Application to renew the Power
Reactor Operating licence for the
Darlington Nuclear Generating Station

Commission Public Hearing
Part 2

DARLINGTON SEVERE ACCIDENT ISSUES

Sunil Nijhawan, Ph.D. P.Eng

VULNERABLE LOW PRESSURE CONTAINMENT WITH SMALL REACTOR BUILDINGS, POOR D₂ MIXING

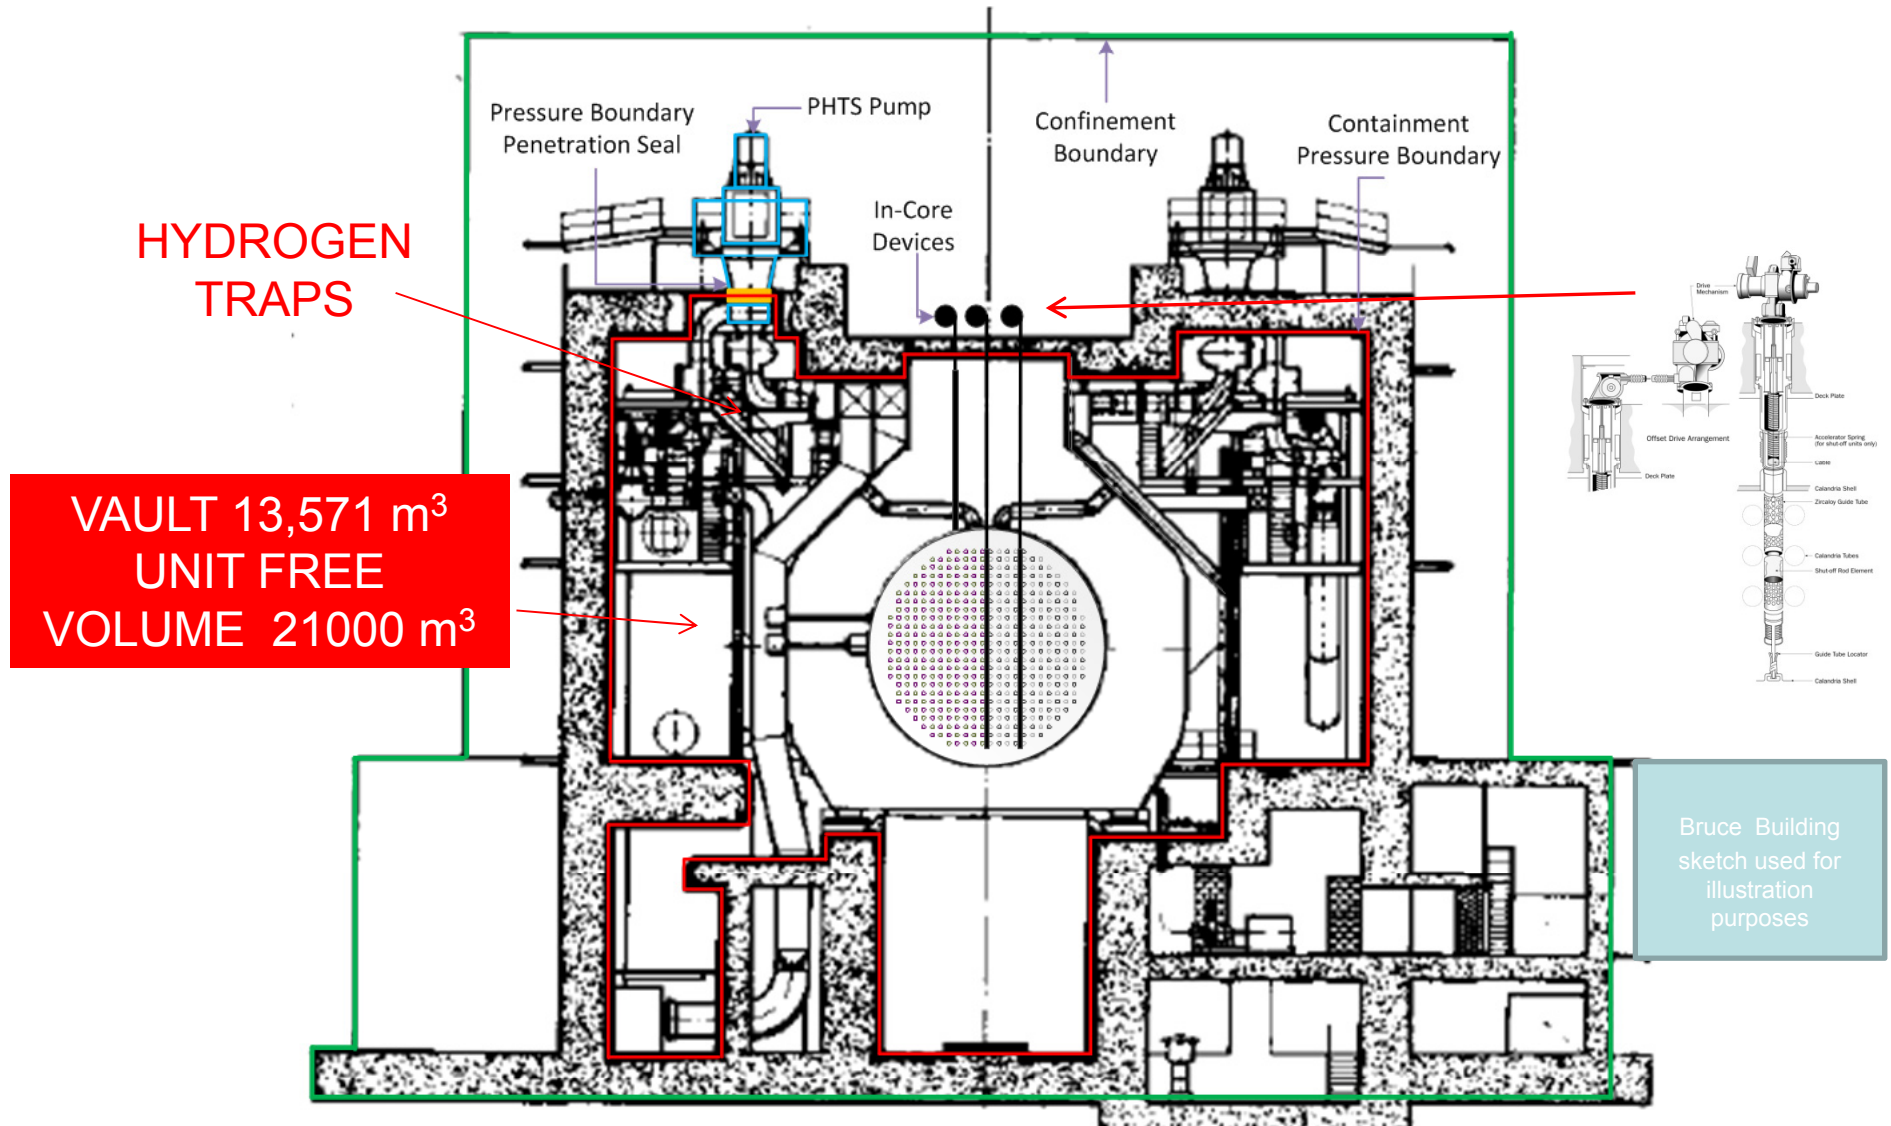
Total free volume 120,000 m³ for 4 units, 95000 m³ in vacuum building,
max design pressure 48 kPa(g) at VB, 96.5 kPa(g) reactor vault

FOUR
REACTOR S
LOCATED AT
PRESSURE
BOUNDARY
INTER-
CONNECTED
BY FUELLING
MACHINE
DUCT AND
VACUUM
BUILDING

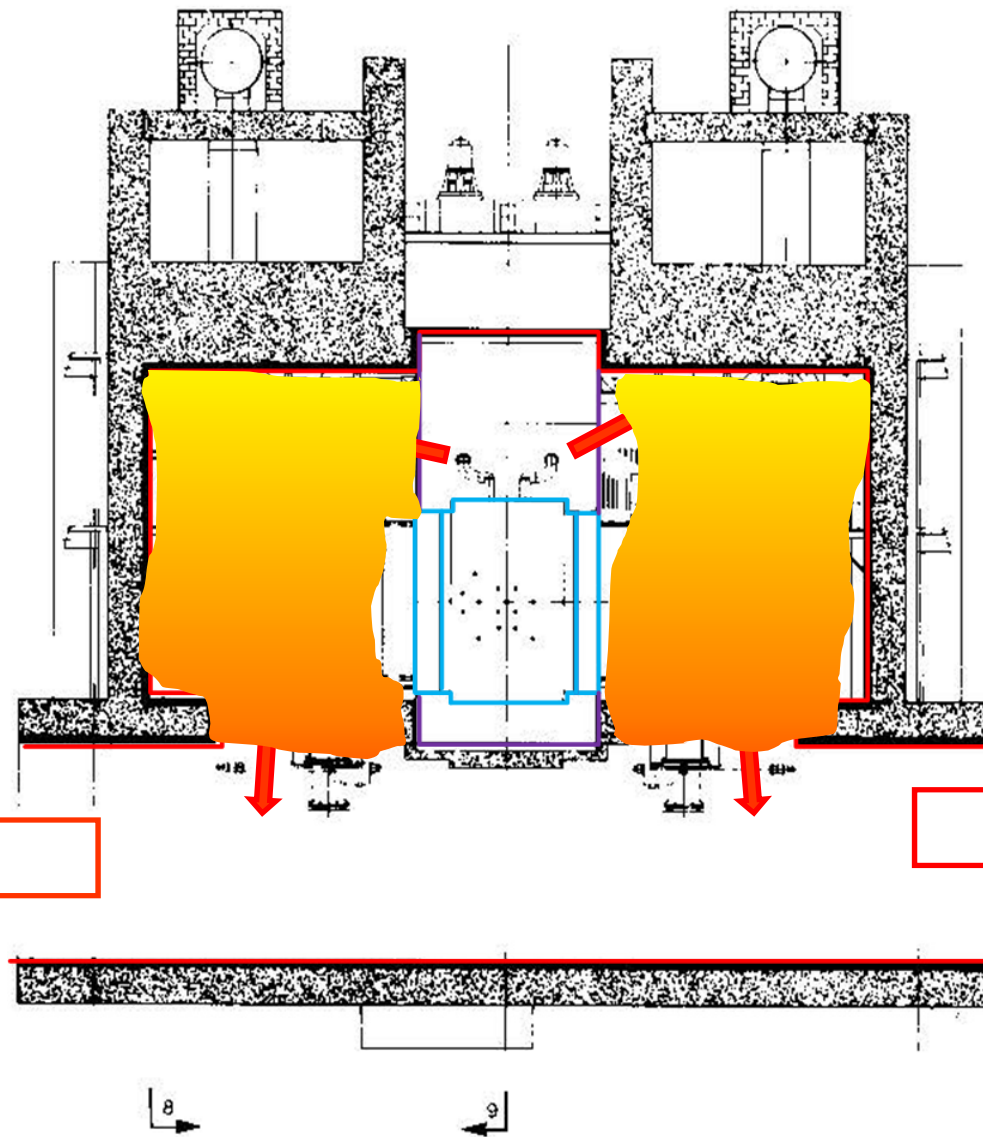
DESIGN
PRESSURE
0.93 atm (96.5
kPa(g))

VACUUM
BUILDING
DESIGN
PRESSURE
0.5 ATM

Bruce Building
sketch used for
illustration
purposes

SRVs

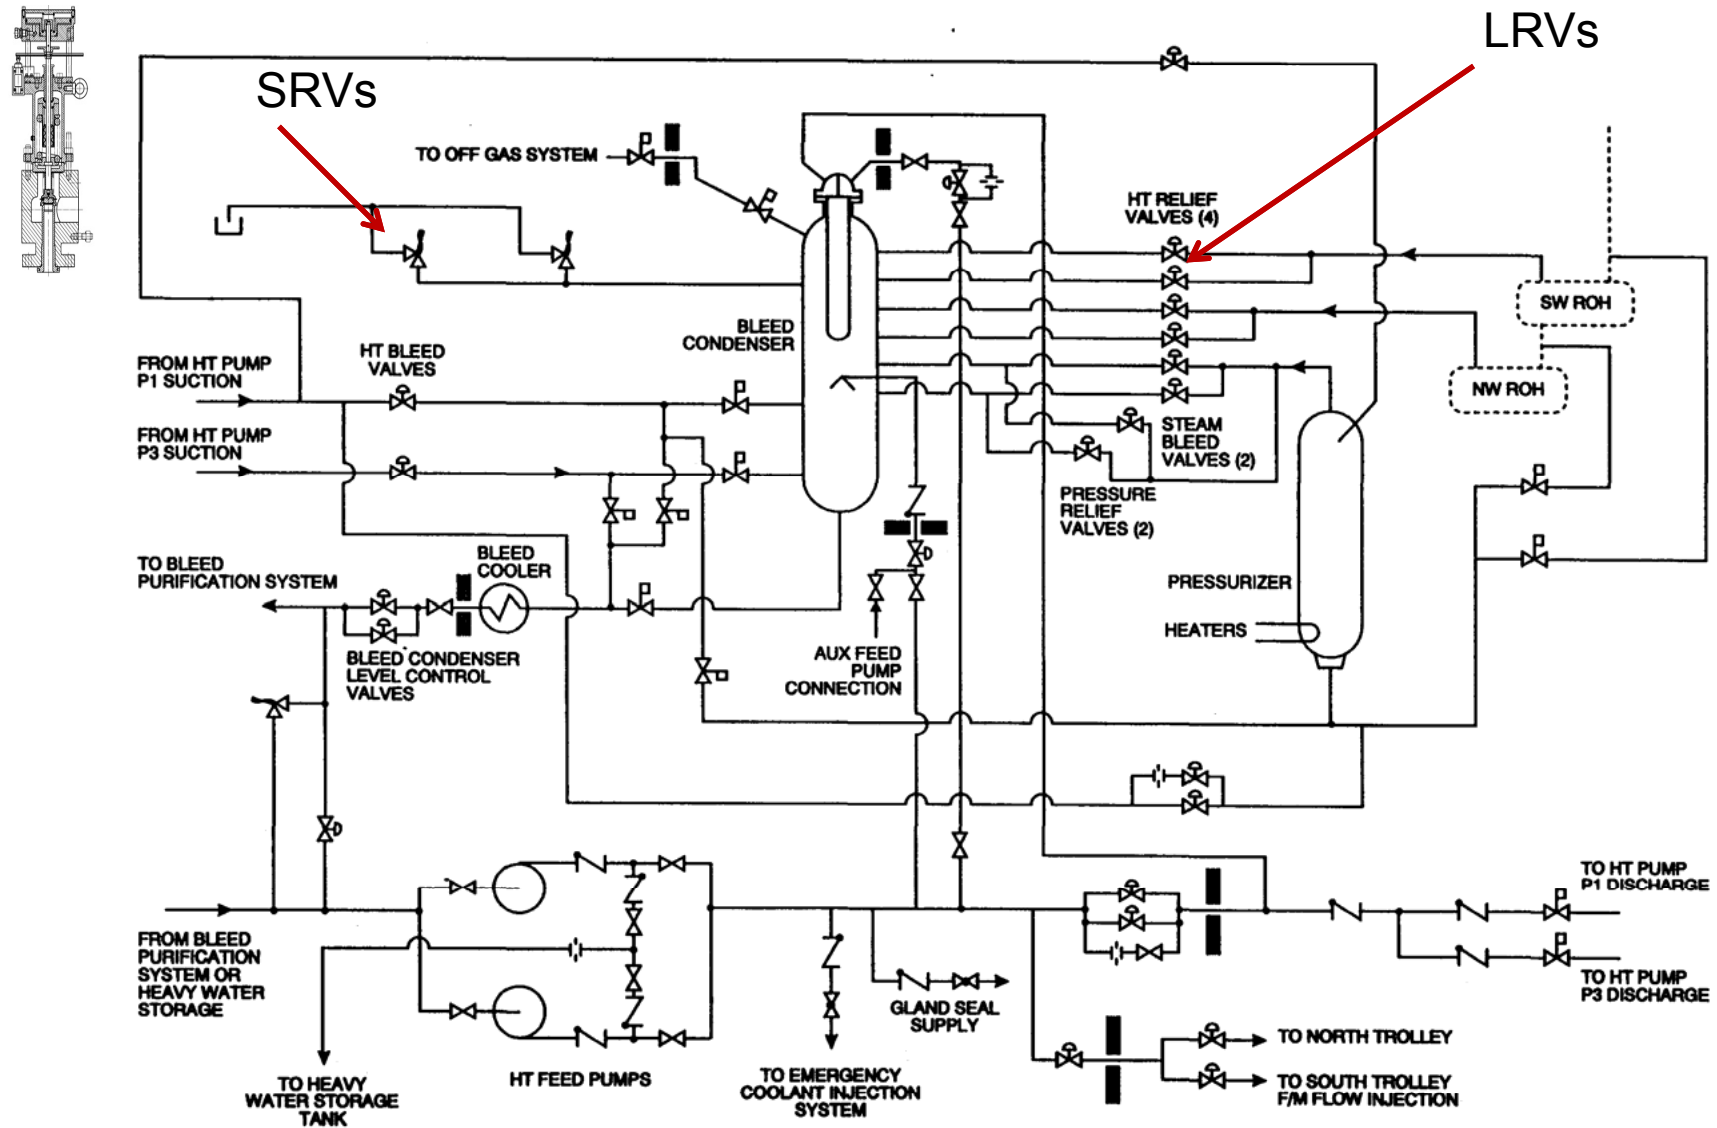
- TWO '100%' SAFETY RELIEF VALVES ON BLEED CONDENSER (63332-RV25,26, NPS 4x6)
- RATED CAPACITY 100 l/s of LIQUID D₂O
- STEAM D₂O CAPACITY REPORTED TO CNSC IN 2003 BY OPG AT 1.5 kg/s per VALVE
- ONLY ONE VALVE REQUIRED FOR OPERATION
- VALVES ARE IMPROPERLY DESIGNED FOR LOSS OF HEAT SINKS

INSTALLED SAFETY VALVES CANNOT RELIEVE DECAY HEAT
